ADDENDUM NO. 01

PROJECT NAME: DENTAL SCHOOL LOUNGE RENOVATION

project name: CU Dental School Student Lounge
project #: 2022.101
current date: 12/4/2023

School of Dental Medicine (L26) First Floor

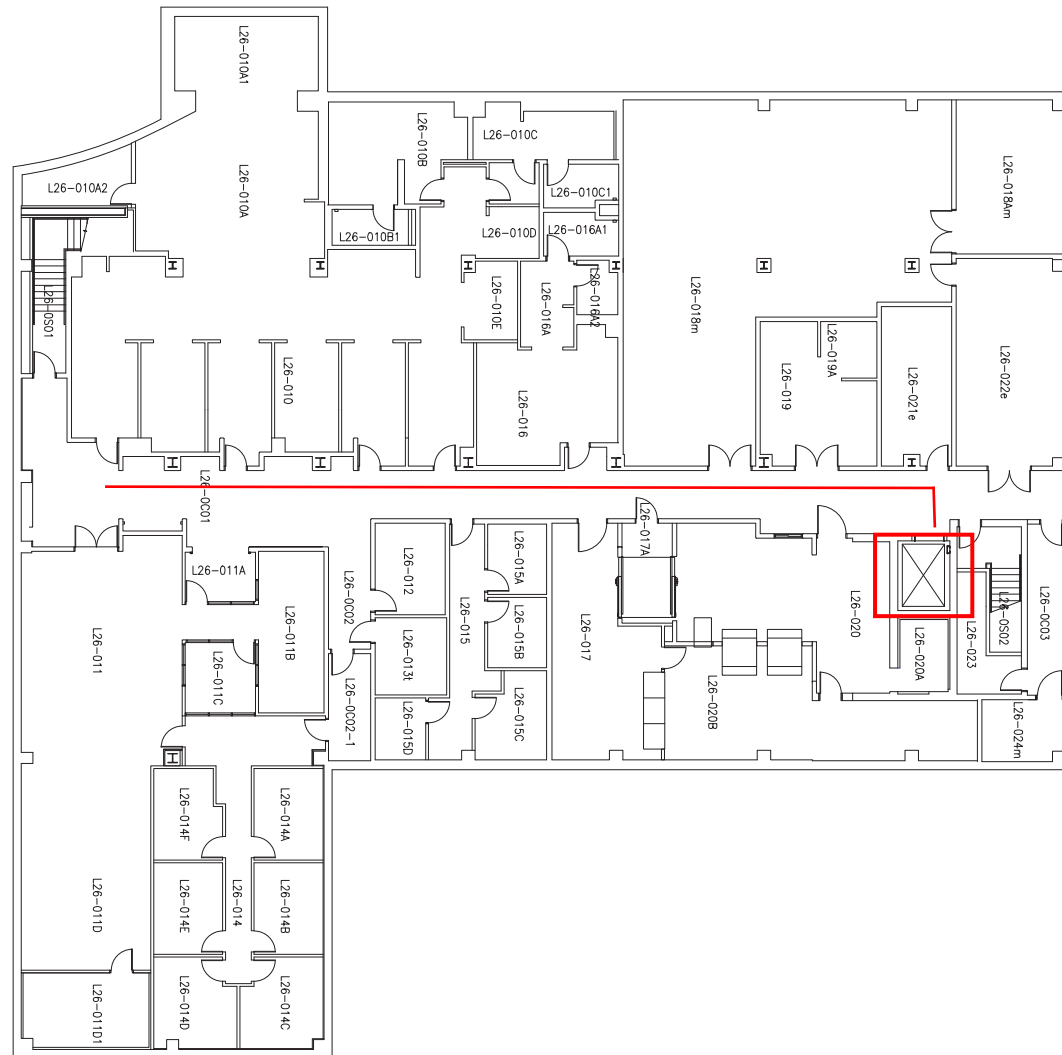
Where is the location of the loading dock for access?		CU Anschutz		Please reference Attachment #1 & 2 for plans provided by CU Anschutz for loading dock and freight elevator access.

First Floor Loading Dock- North West Corner of Building
